Proposed Revisions to a Standard Plans Index

Index Number: 450-511

Index Title: BEARING PLATES (TYPE 1) - PRESTRESSED
FLORIDA-I AND AASHTO TYPE II BEAMS

LAST REVISION 07/01/14	DESCRIPTION:	FY 2023-24 STANDARD PLANS	BEARING PLATES (TYPE 1) - PRESTRESSED FLORIDA-I AND AASHTO TYPE II BEAMS	INDEX 450-511	SHEET 1 of 2
---------------------------	--------------	------------------------------	---	------------------	-----------------

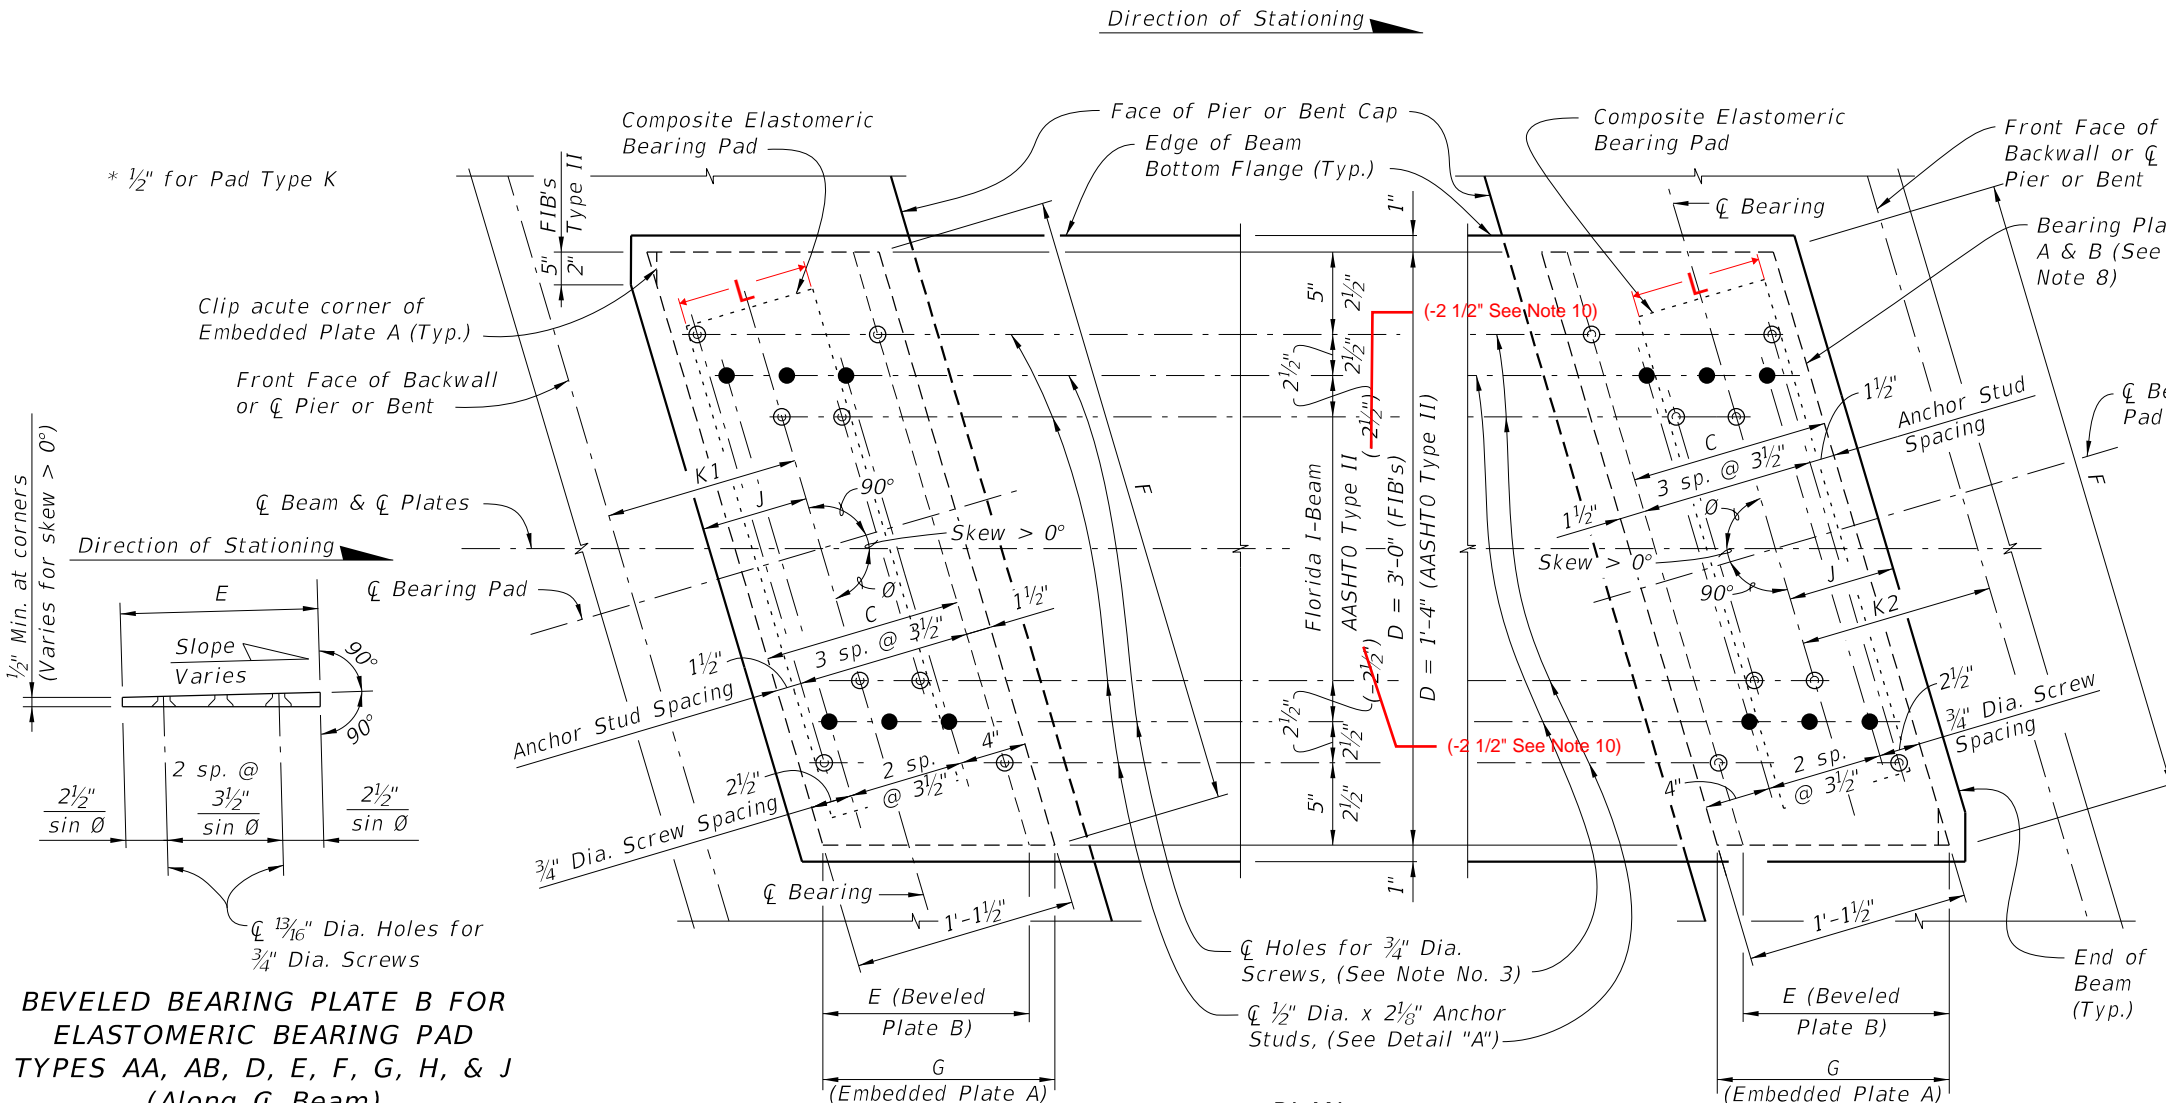
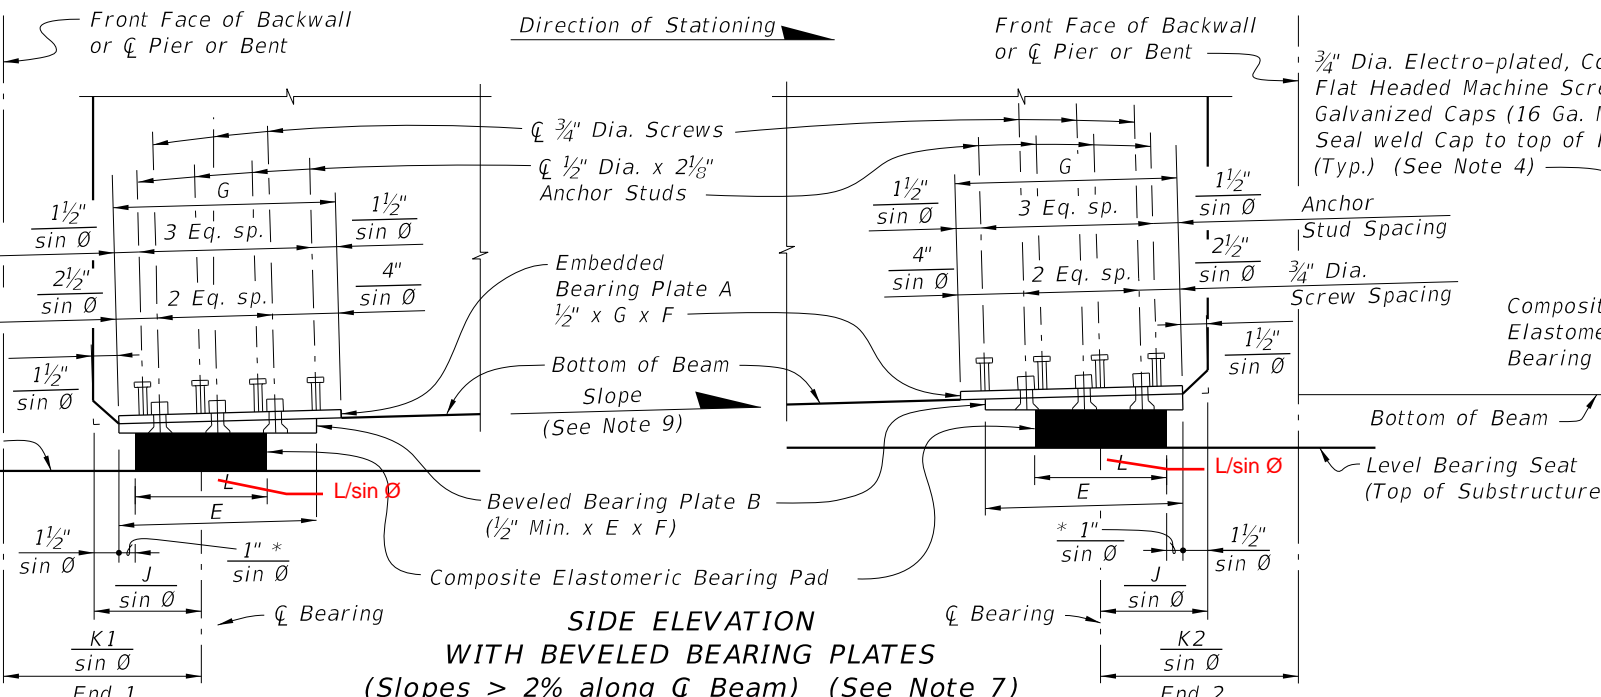
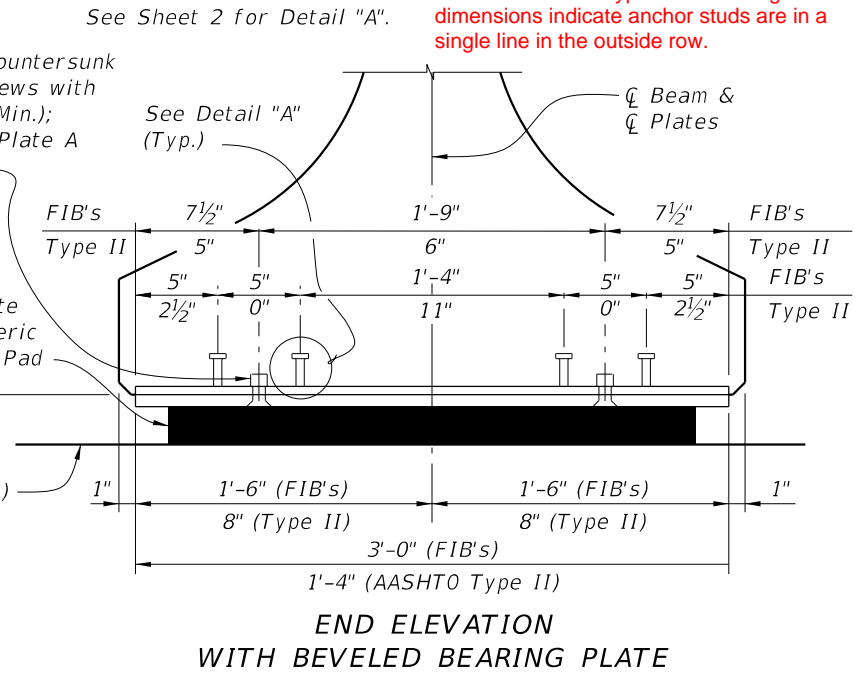
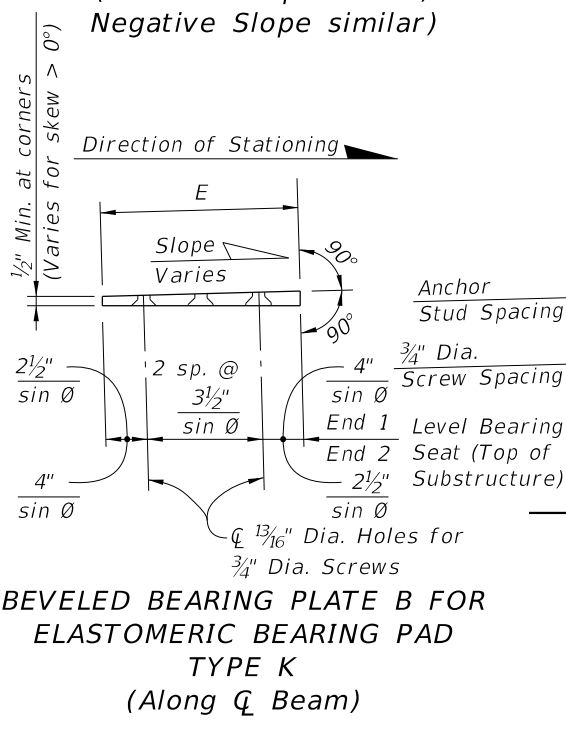
Sheet 1: Changed Dimension L to account for the skew angle; Added Dimension L on plan; Added note clarifying negative dimension for AASHTO Beam anchor studs.

We got an email in noting that dimension L was called out incorrectly not accounting for the skew. They also asked what a negative dimension meant for the AASHTO Beam anchor studs. We decided to add clarity for the negative dimension whose purpose was to have the anchor studs in a single row for the AASHTO Beam Type 2 although in plan its shown as multiple rows for the sake of using one detail for multiple configurations.

- CROSS REFERENCE:** See Sheet 2 for Detail "A".
- 10. For AASHTO Type II Beams negative dimensions indicate anchor studs are in a single line in the outside row.**
